# UNITED STATES PATENT AND TRADEMARK OFFICE

| APPLICATION NO.   | FILING DATE | FIRST NAMED INVENTOR | ATTORNEY DOCKET NO. | CONFIRMATION NO. |
|---|-------------|----------------------|---------------------|------------------|
| 10/511,227  | 05/24/2005  | Erwan Pincemin       | 5284-46PUS          | 2078             |

# Office Action Summary

## DETAILED ACTION

Figure O1

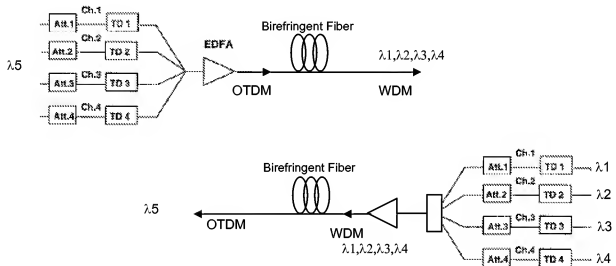
Based on the non-linear optical theory, and also indicated by Hatami-Hanza et al, the amount of frequency shift depends on the pulse peak power. As shown in the top panel of Figure O1, the pulse power level can be controlled by the attenuator (Att. in Figure O1) and the timing position of the pulse is controlled by the time delay (TD in Figure O1), and then through the birefringent fiber, the single wavelength OTDM signals are converted into WDM signals having four different wavelength. It is obvious to one skilled in the art to use the same principle and the birefringent propagating medium of Hatami-Hanza et al to convert the WDM signal to OTDM signal. As shown in the bottom panel of Figure O1, the attenuator (Att.) and time delay (TD) can be used to control the power level and timing position of the pulses of the WDM signals which are simultaneous and carried at the different wavelengths, then the birefringent fiber can be used to convert the four-wavelength WDM signal into single wavelength OTDM signals.
